ECLIPSE
AEROSPACE

SERVICE BULLETIN

NUMBER: SB 500-21-001, REV B
MODEL: ECLIPSE EA500
SUBJECT: OUTFLOW VALVE STATIC LINE SECURITY

Outflow Valve Static Tubes
Figure 1

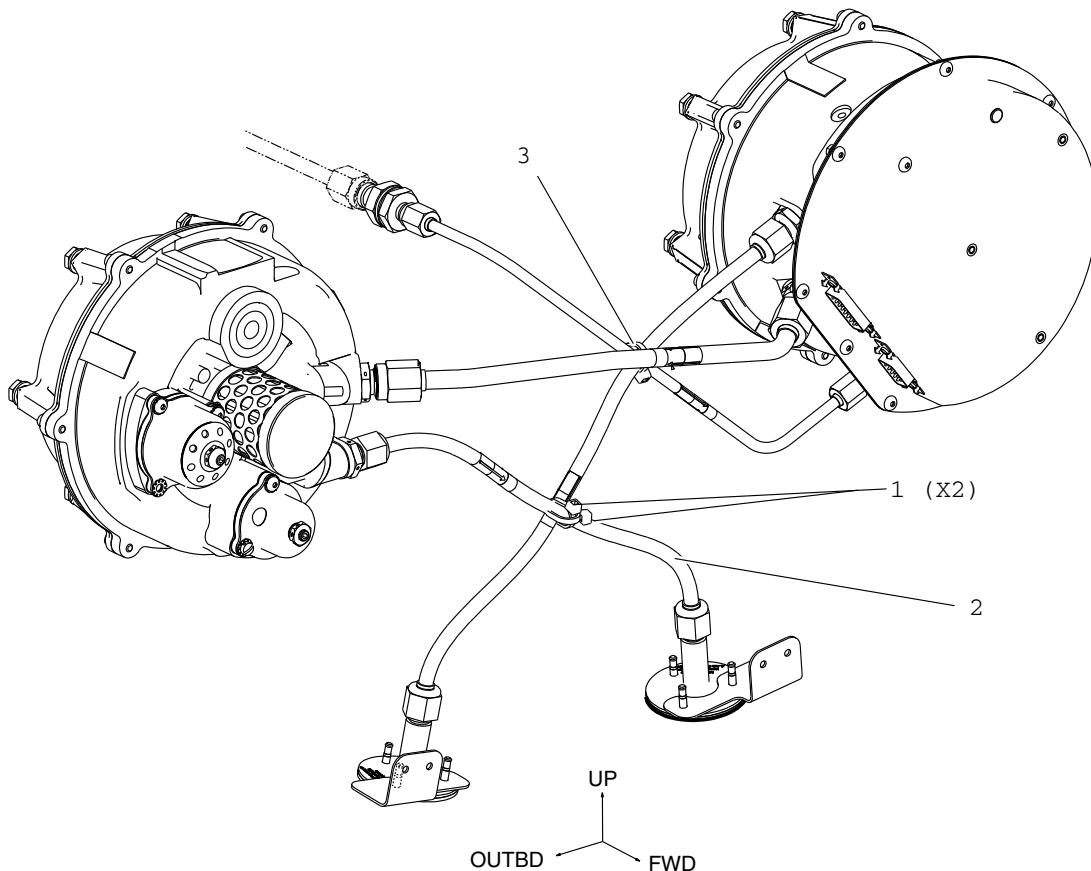
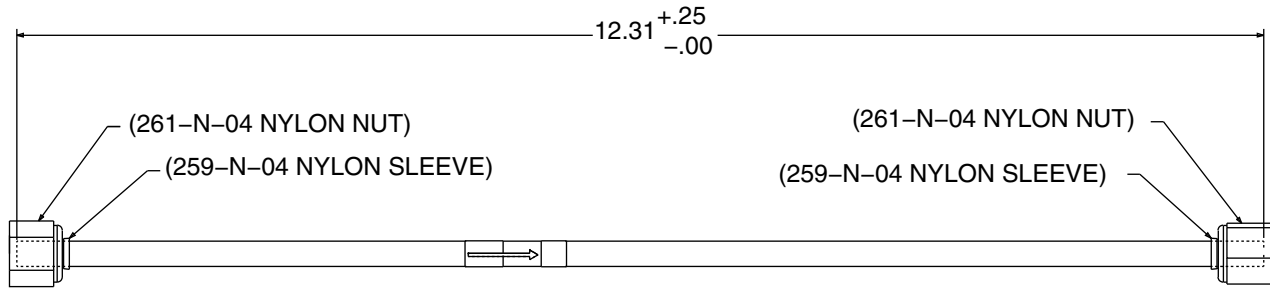
- (2) Remove passenger seats as required to gain access. Refer to AMM 25-21-10 - PASSENGER SEAT REMOVAL.
- (3) Remove 231 NZ - Floor Panel, Baggage Compartment. Refer to AMM 25-21-30 - CABIN FLOOR PANELS - REMOVAL.
- (4) Replace Secondary Static Tube Assembly as follows:
 - (a) Remove Secondary Static Tube Assembly P/N 21-104616-1002 (2, Figure 1).

- (b) Install Secondary Static Tube Assembly P/N 21-104616-1003(2, Figure 1). Tighten Nylon Nuts 2 to 2.5 turns total engagement.
- (5) Remove Secondary Static Tube Assembly P/N 21-104616-1002 (2, Figure 1) and rework as follows:
 - (a) Cut Secondary Static Tube Assembly P/N 21-104616-1002 with Tubing Cutter to new length. Refer to (New Length , Figure 2).

- (6) Install two tie straps (lower tie straps) (1, Figure 1) vertically and laterally to primary and secondary static tubes as low as possible without kinking tubes. Maintain 0.5 inch minimum clearance from the flight control cables.

- (7) Install upper tie strap vertically and laterally (3, Figure 1) to primary static and bulkhead to primary tubes as high as possible. Maintain 0.5 inch minimum clearance from the flight control cables.

Nylon Nut and Sleeve Installation
Figure 3

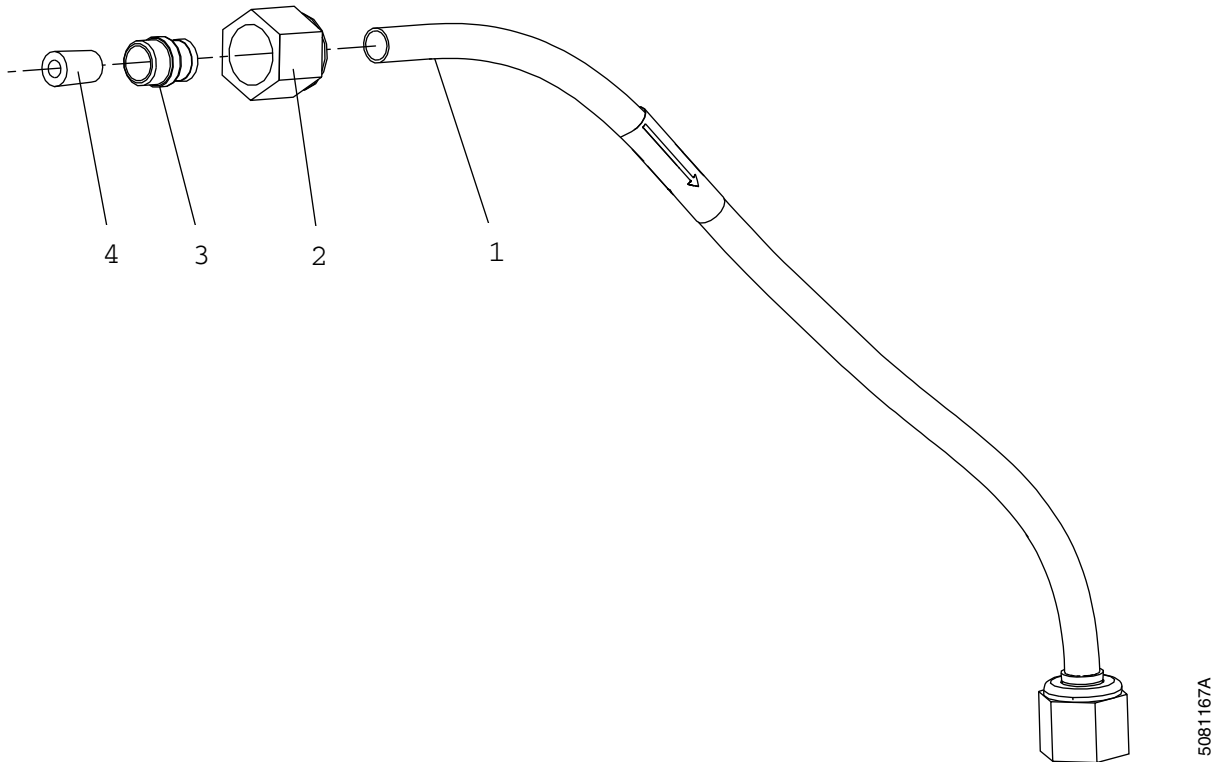
- (b) Slide Nylon Nut P/N 261-N-04 (2, Figure 3) onto Static Tube Assembly (1, Figure 3). Slide Nylon Sleeve P/N 259-N-04 (3, Figure 3) on to end of the tube (1, Figure 3). Insert Ferrel (4, Figure 3) into end of tube.

- (c) Reidentify Secondary Static Tube Assembly (1, Figure 3) with permanent ink marker "21-104616-1003".
- (d) Install reworked Secondary Static Tube Assembly (2, Figure 1). Tighten Nylon Nuts 2 to 2.5 turns total engagement
